September 28, 2018

**RE: Signal Village Subdivision
Signal and Ventura NE
Grading Plan Stamp Date: 9/10/18
Drainage Report Stamp Date: 9/10/18
Hydrology File: C20D078**

Based on the submittal received 9/11/18, the above referenced project cannot be approved for Preliminary Plat until the following are corrected:

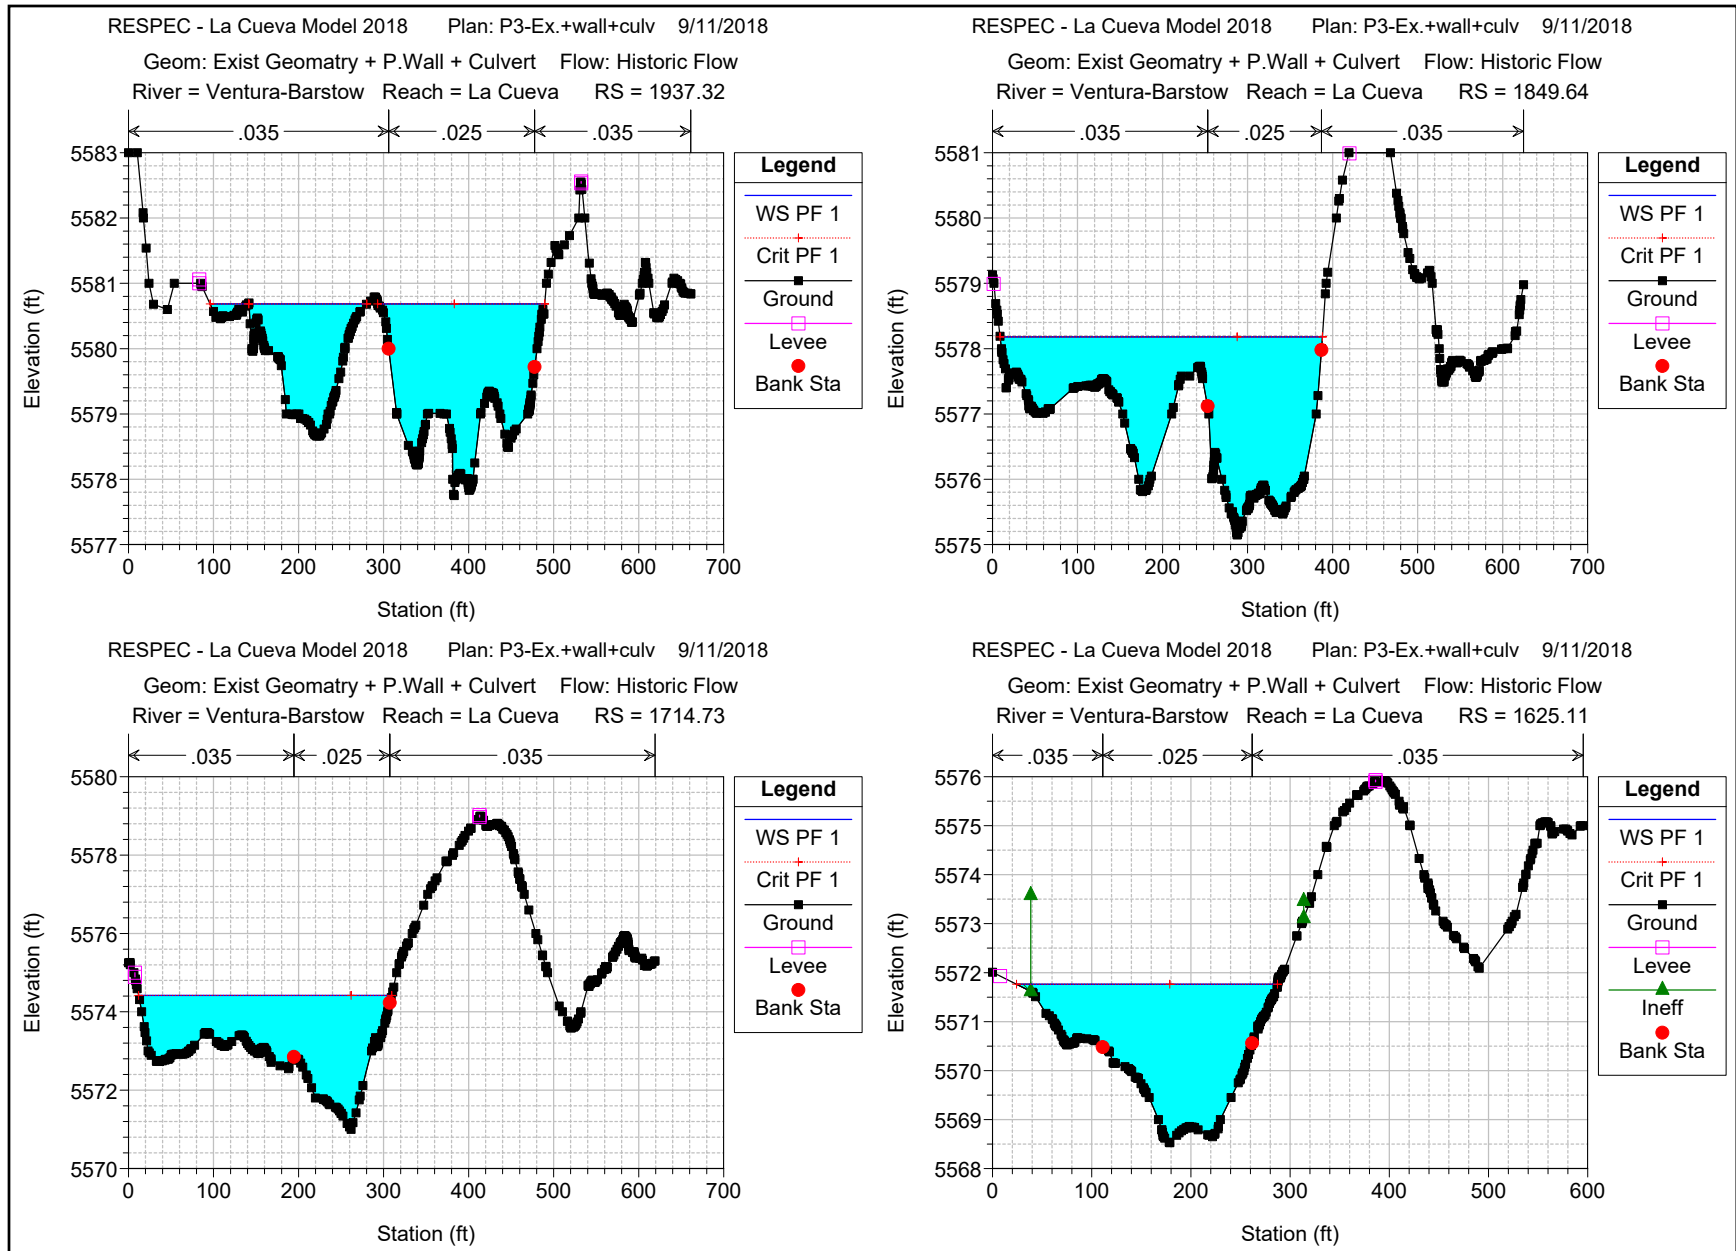
- c. Any private encroachment into neighboring private property will require written and signed permission from both property owners.
6. The HEC-RAS model of future conditions must include either 7 or 8 10'x6' CBCs with the invert at about 5562'. The future culvert must be 60' long and shown on the arroyo profile.

8. The HEC-RAS model of proposed conditions must include a section at the east boundary of the subdivision showing the area south of the floodwall ineffective and a 45degree contraction upstream of that section. If the lot elevations next to Ventura are not elevated above the 100-yr WSEL, plus freeboard, then the east property line must be designated as a levee and all design requirements of FEMA (44CFR, Ch.1, Section 65.10) must be demonstrated in this report.

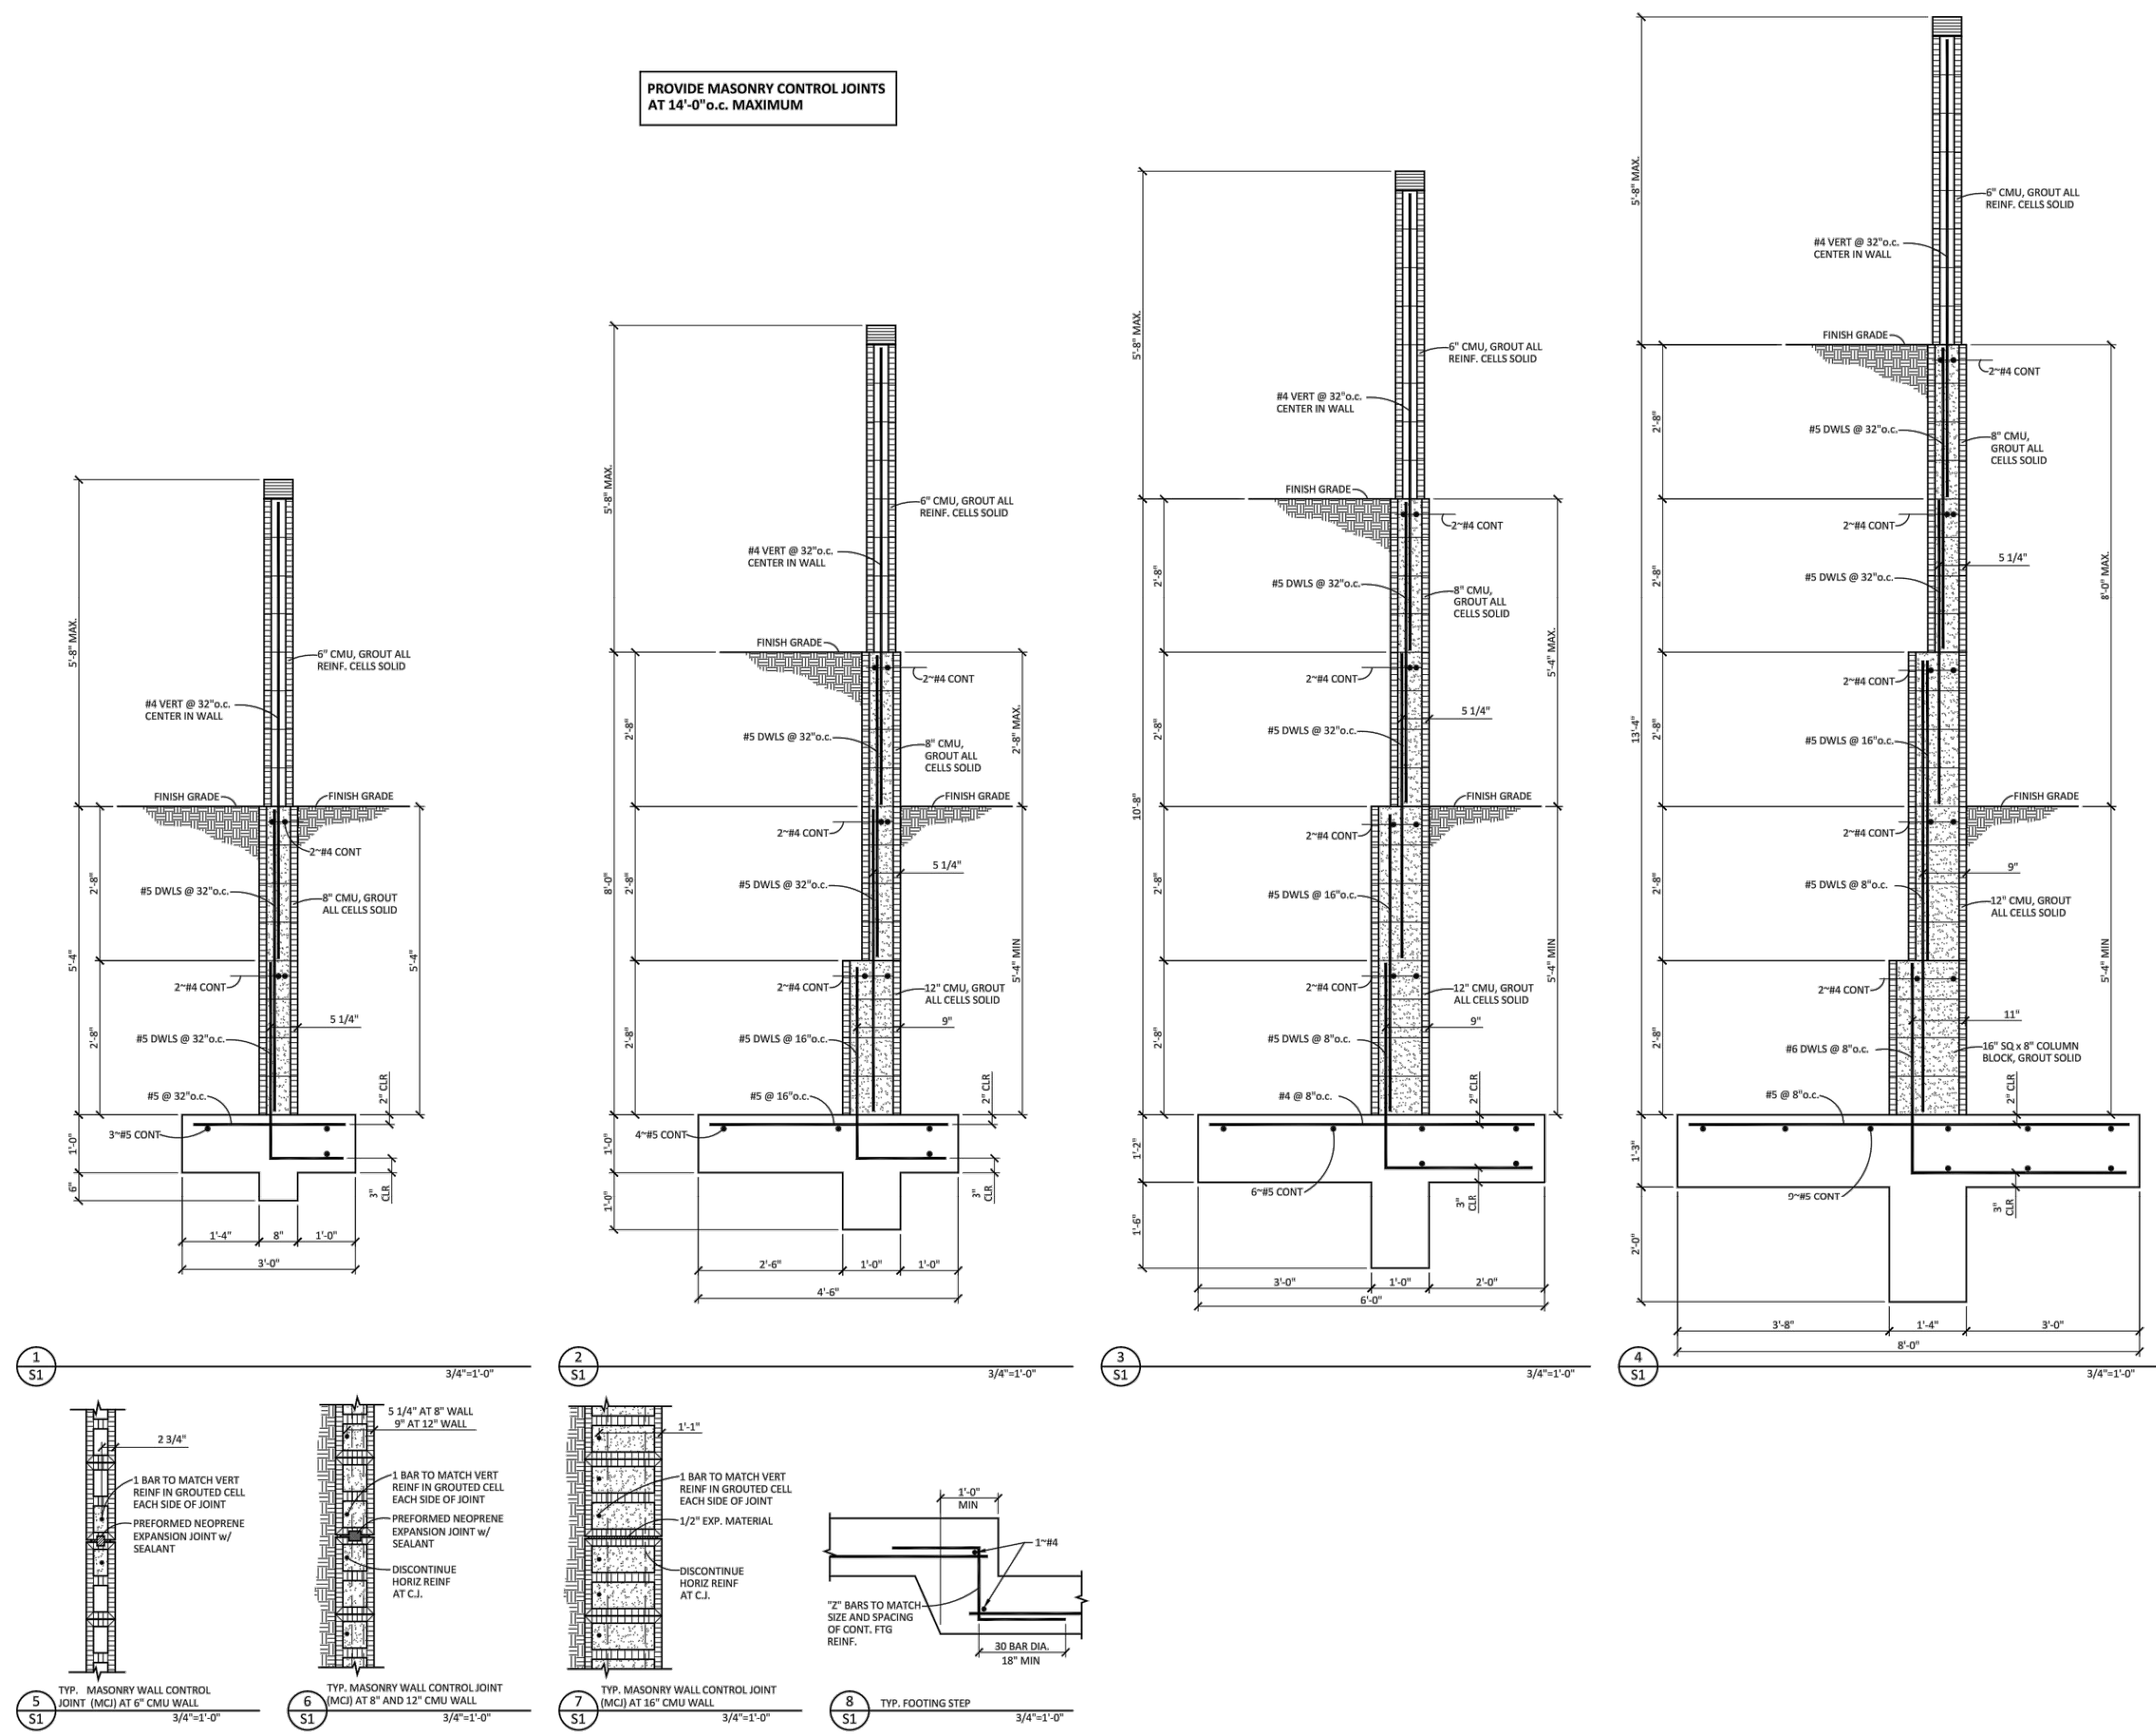
1. Show all infrastructure improvements on the grading plan, especially curb and gutter and sidewalk on Ventura. The return is not in the correct location at Signal/Ventura intersection. Ventura improvements must include curb and gutter and sidewalk and ½ section collector paving section for the full length of frontage. These improvements provide adequate protection from scour so a scour wall is not required on the east side of the project. Dimension face-to-face of curb, and sidewalks on both sides of the centerline. Show connections and transitions to the existing curb and pavement on Signal.

2. Show and label the existing and proposed contours, including all proposed grading both onsite and offsite and label limits of grading. Extend limits of existing topo to include the ROW on Ventura, south of the Ventura/Signal intersection; include curb returns.

3. Provide additional details for the first flush pond; show the water surface elevations for both the first flush volume and the 100-yr volume. Include supporting calculation for the overflow channel as well (Both the overflow channel and the pond will need to be dedicated as private drainage easements on the Plat). Correct notes on the grading and drainage plan under *Developed Drainage Condition* to describe the central first flush pond and its overflow north to the arroyo, not south to Signal.

9. Show typical sections of the channel improvements on the grading and drainage plan with proposed contours in plan view and provide written permission and public easements for offsite grading.

11. The scour wall is shown as being constructed from CMU block which is constructed in level runs, but the profile shows the scour wall as sloping along its length. The location of the steps should be called out on the plan for the footer and top of wall.
